Ultra3000 Digital Servo Drive Installation Manual

About This Publication

This document updates information about the Ultra3000 digital servo drive products. Use this document in conjunction with the Ultra3000 Digital Servo Drive Installation Manual, publication 2098-IN003E-EN-P. To obtain a copy, contact your local Rockwell Automation sales office, distributor, or online at <http://literature.rockwellautomation.com>.

Figure 2.57
RS-232 to RS-485 Connection Diagram

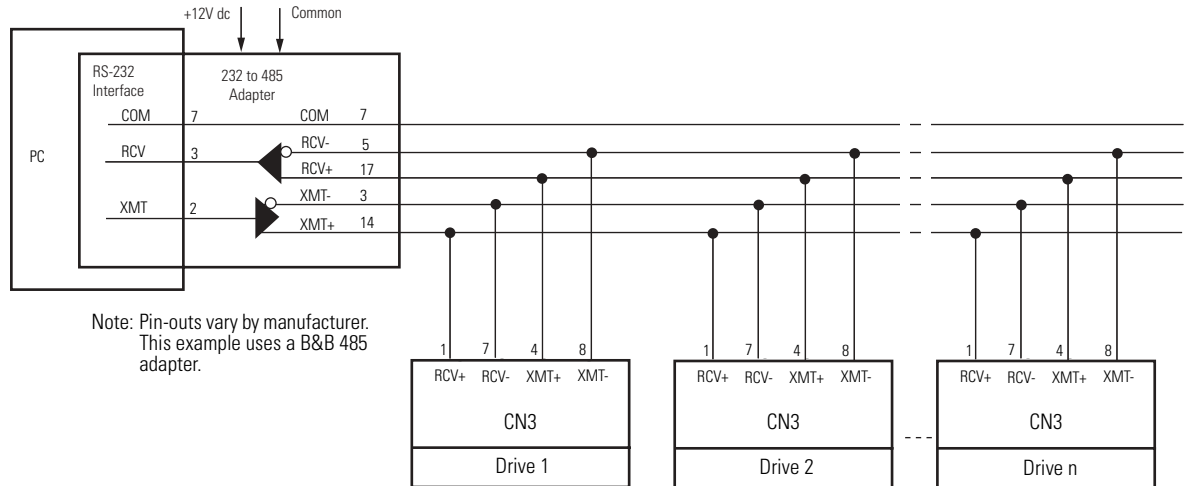
Replace Figure 2.57 on page 2-52 with the one shown below. The new figure correctly identifies the drive connector as CN3.

Figure B.2
Typical Power Wiring of Ultra3000 System
(2098-DSD-030x-xx)

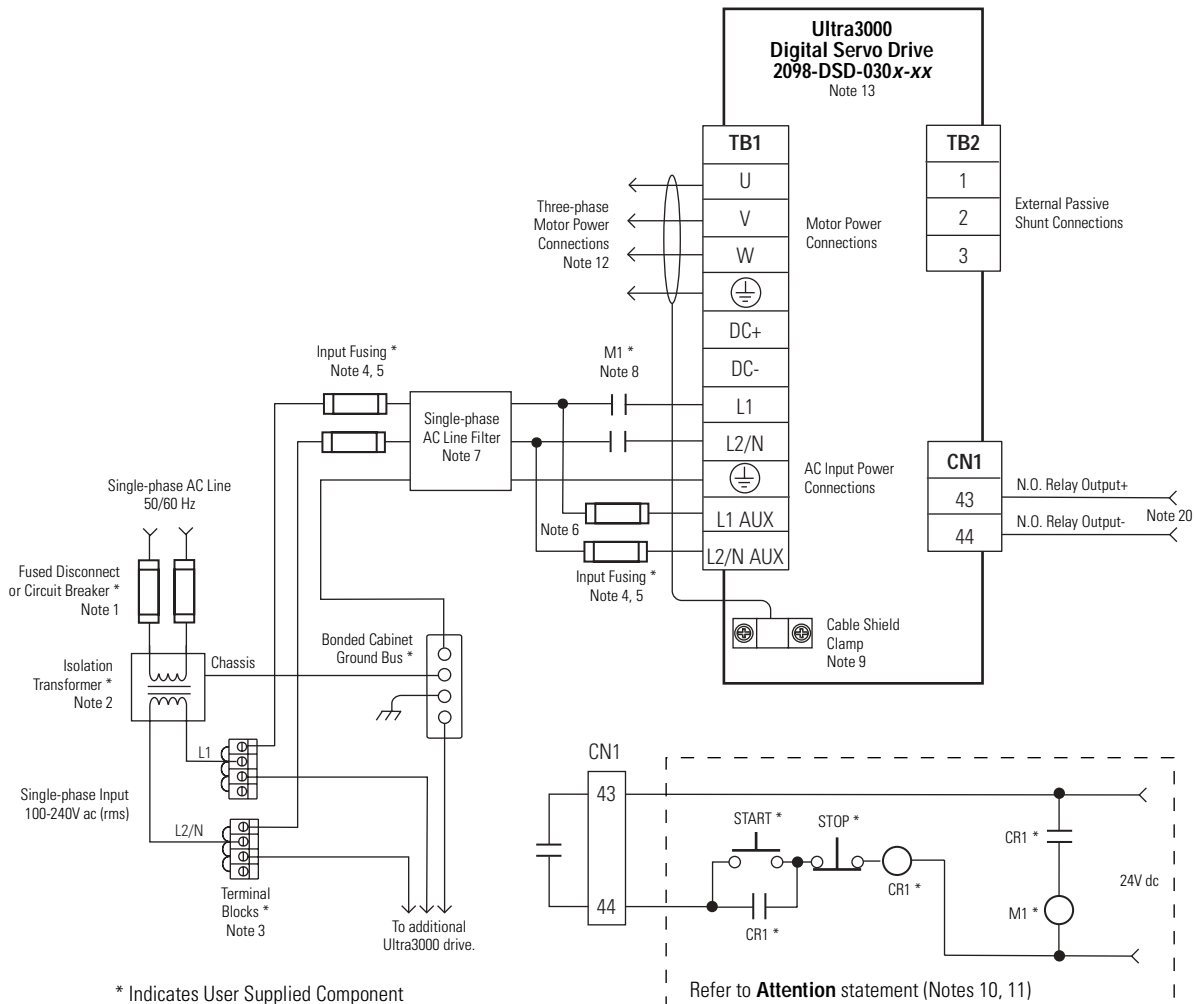
Replace the interconnect diagram on page B-4 with the one shown below. The new diagram changes the recommended wiring of input fusing, ac line filter, and contactor.

Figure B.3
Typical Power Wiring of Ultra3000 System
(2098-DSD-075x-xx and -150x-xx)

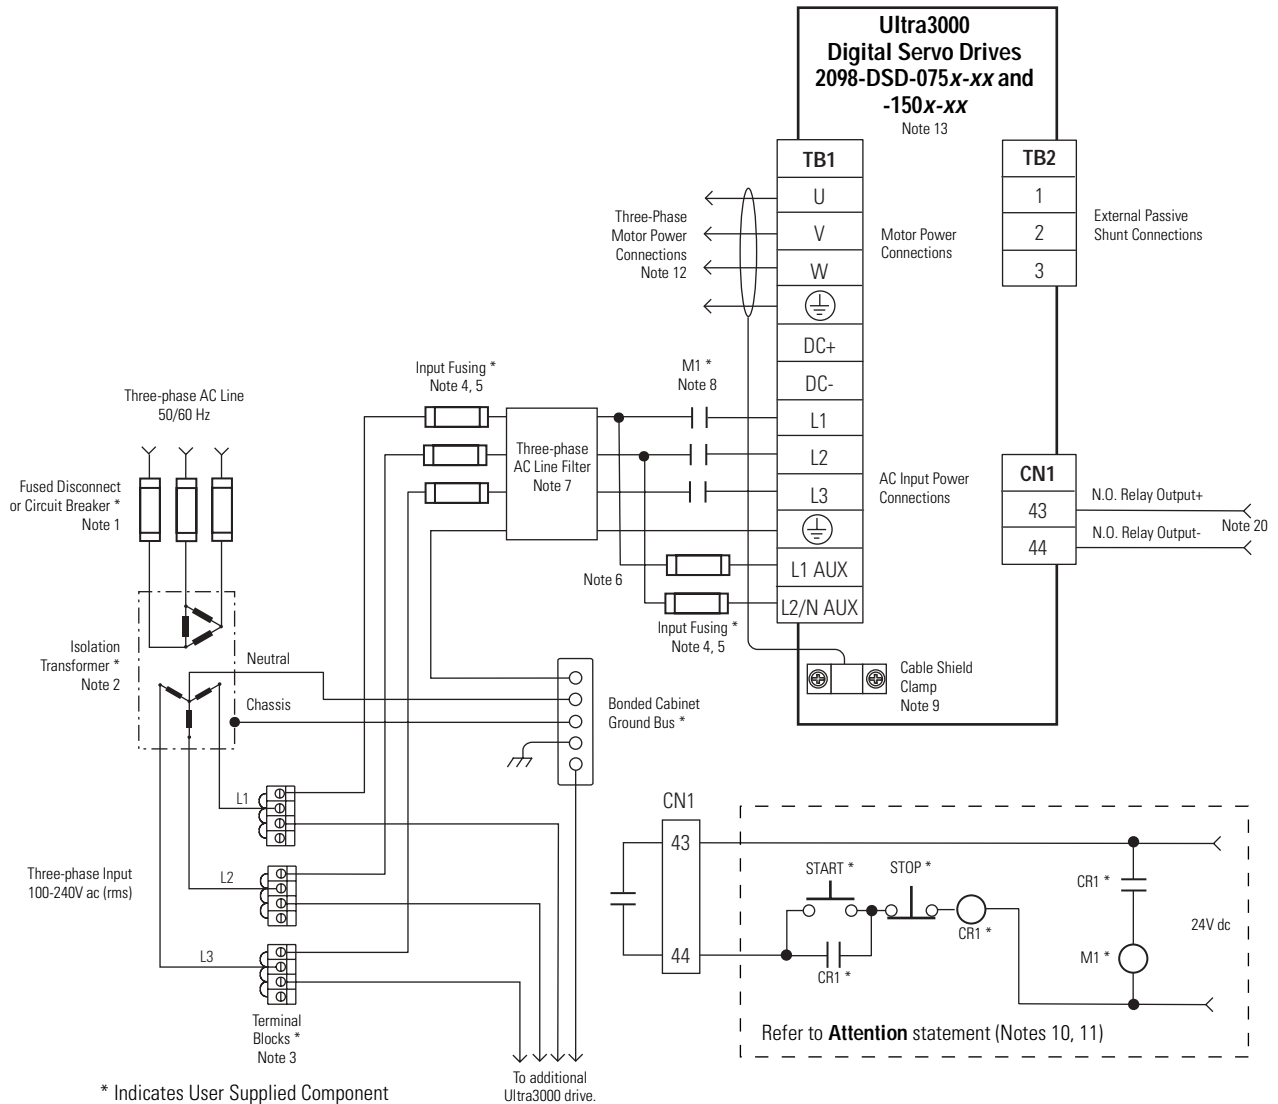
Replace the interconnect diagram on page B-5 with the one shown below. The new diagram changes the recommended wiring of input fusing, ac line filter, and contactor.

Figure B.12
Ultra3000 Drive to MP-Series (MPL-A/B, MPF-A/B, and MPS-A/B) Motors

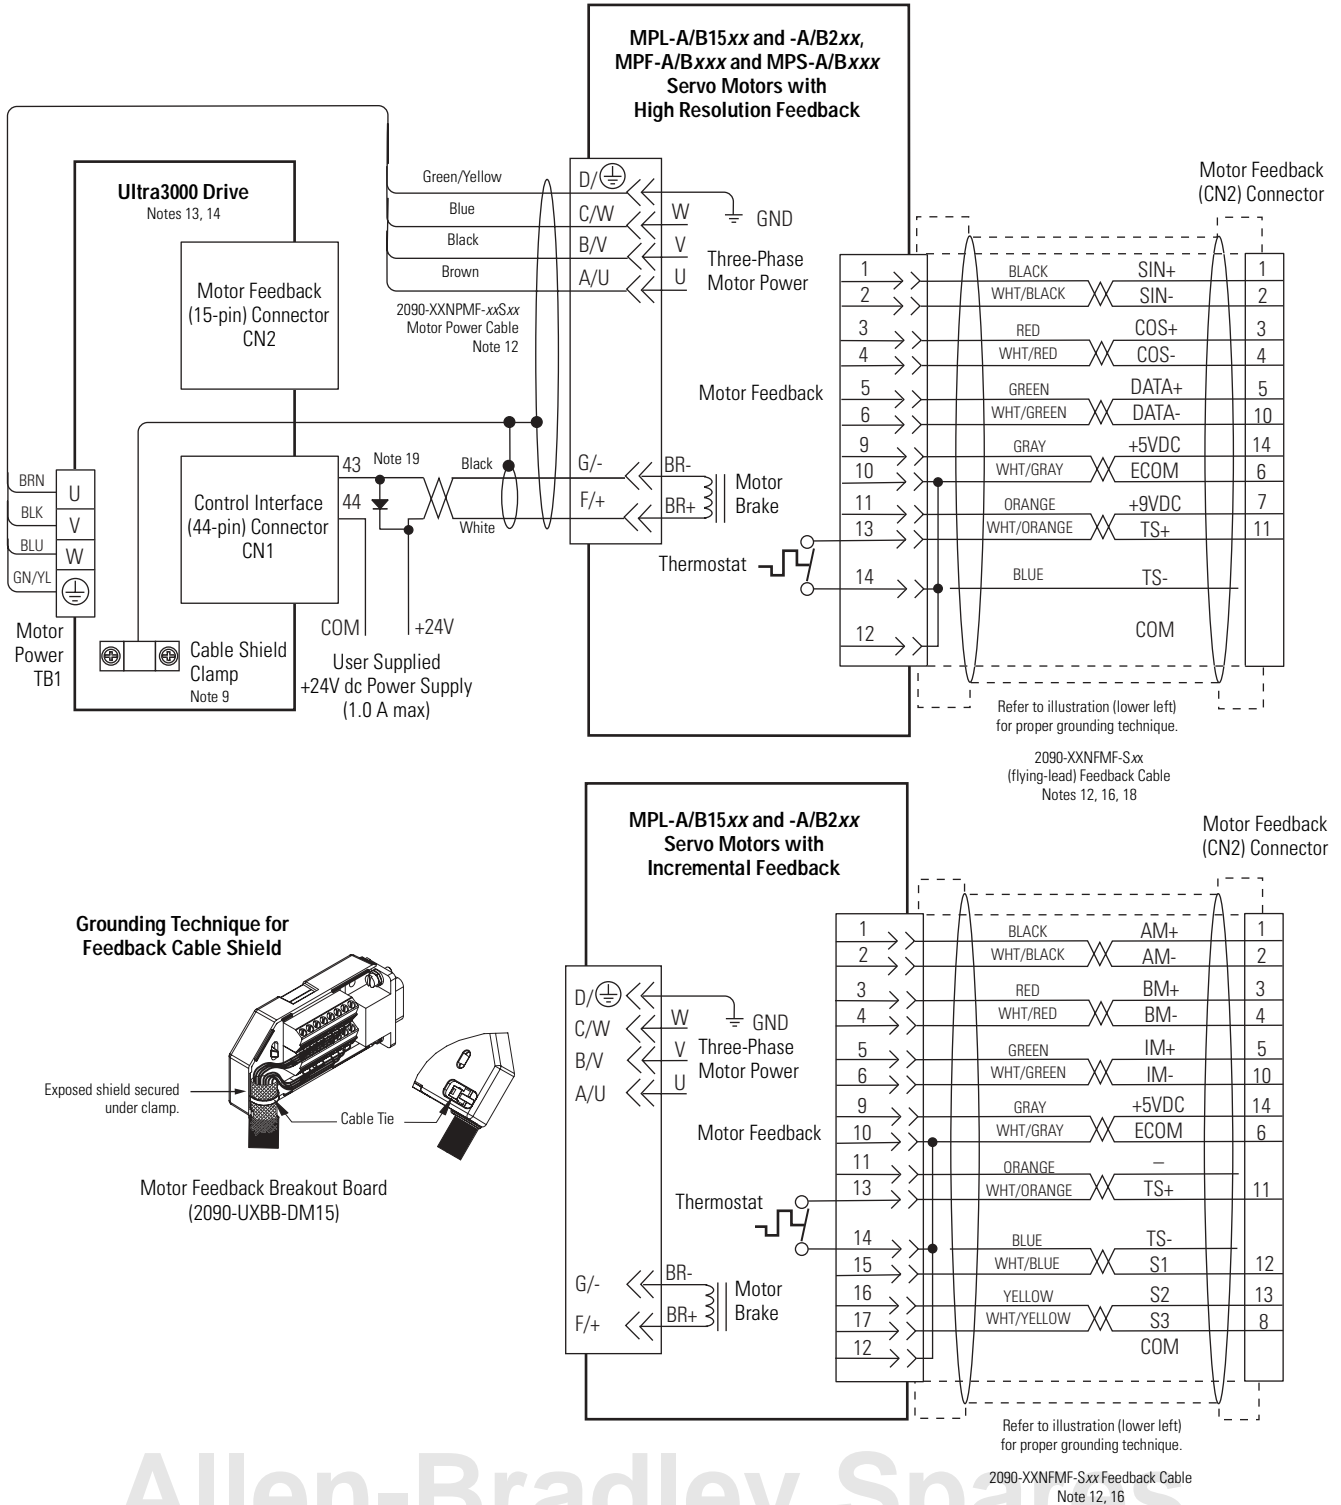
Replace Figure B.12 on page B-12 with the one shown below. The new figure includes MP-Series food grade (MPF), stainless steel (MPS) and low inertia (MPL-A/B15xx and MPL-A/B2xx) motors. Also included is an illustration of grounding the feedback cable shield.

Figure B.13
Ultra3000 Drive to H- and F-Series (230V) Motors

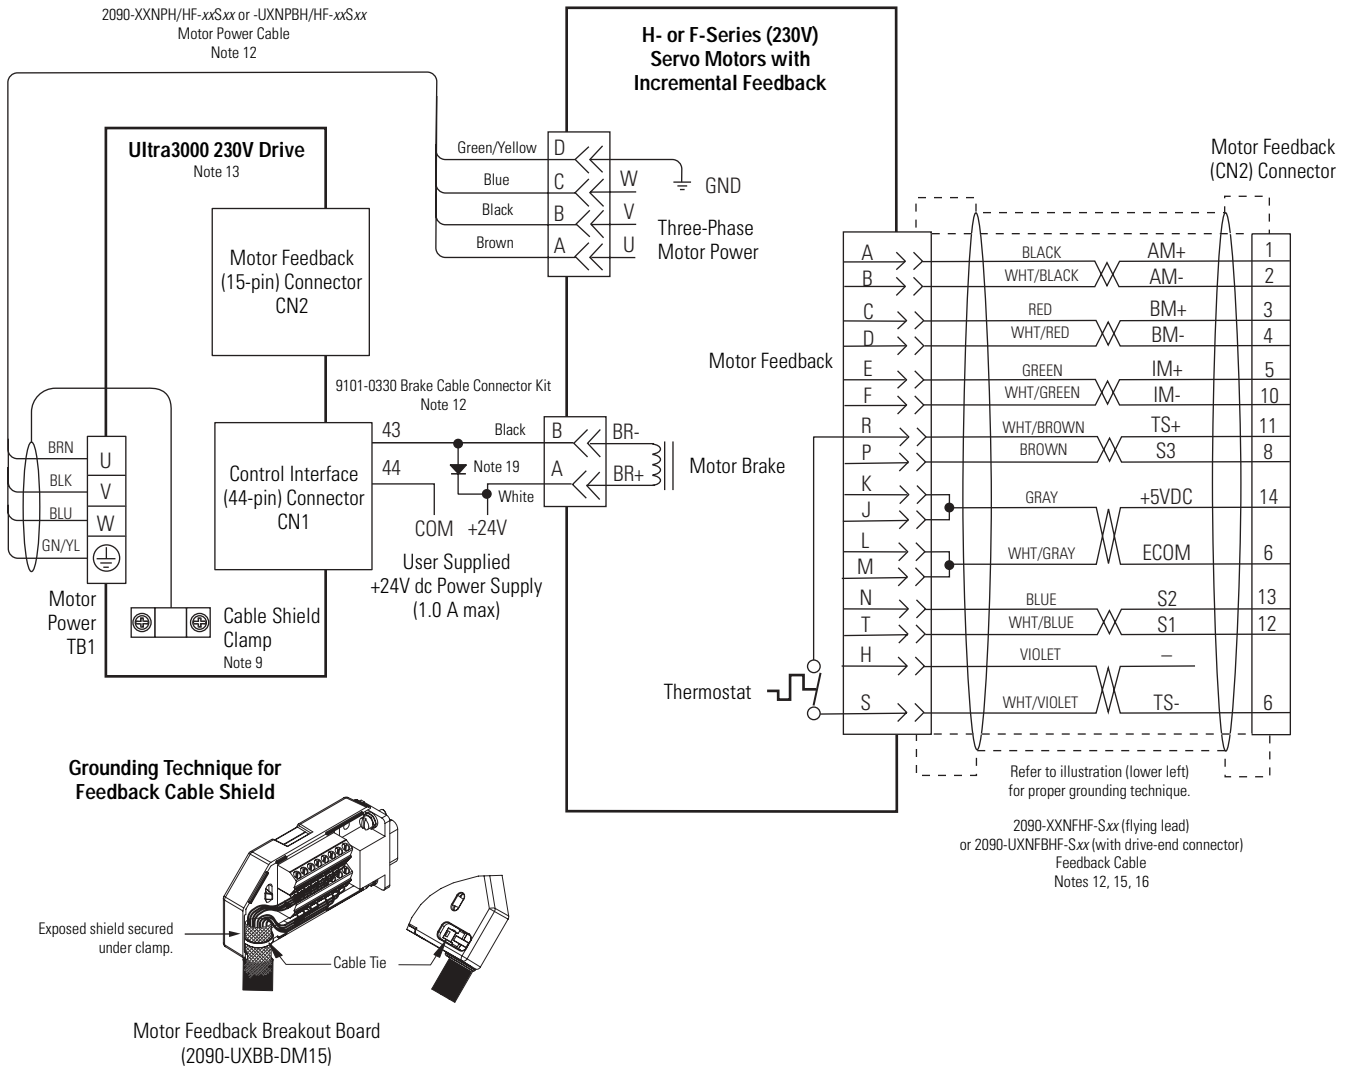
Replace Figure B.13 on page B-13 with the one shown below. The new figure correctly identifies the motor brake-connector pins as A and B. Also included is an illustration of grounding the feedback cable shield.

Figure B.15
Ultra3000 Drive to Y-Series (230V) Motors

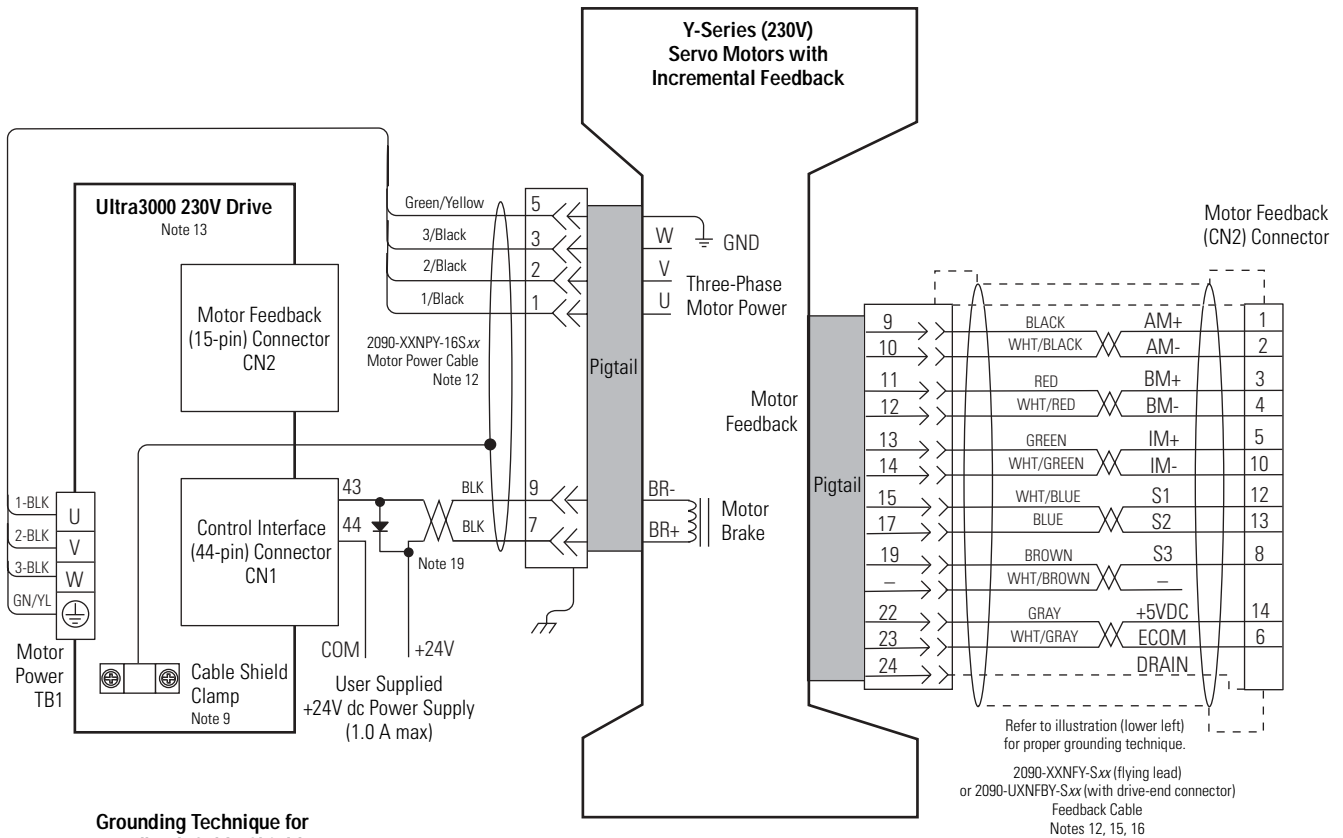
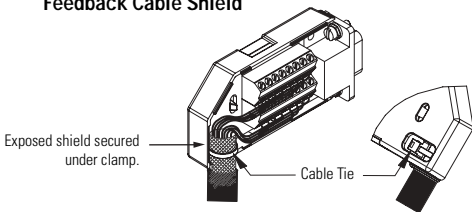
Replace Figure B.15 on page B-15 with the one shown below. The new figure correctly identifies the motor power-cable pins as 1, 2, 3, and 5. Also included is an illustration of grounding the feedback cable shield.

Figure B.19
Example Configuration Controlling a Motor Brake

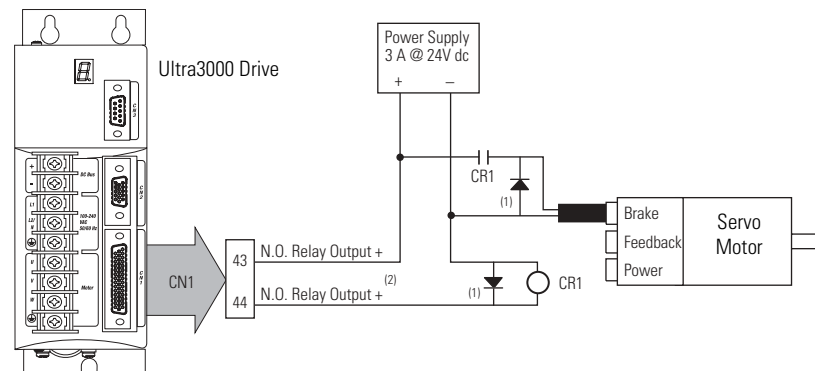
Replace Figure B.19 with the one shown below. The new figure correctly identifies the relay output pins as CN1-43 and CN1-44.

- (1) Flyback diode (1N4004 rated 1.0 A @ 400V dc) or MOV suppresses the collapsing field of the brake coil.
- (2) For non-SERCOS drive, the relay output (CN1-43 and -44) must be configured as a brake.
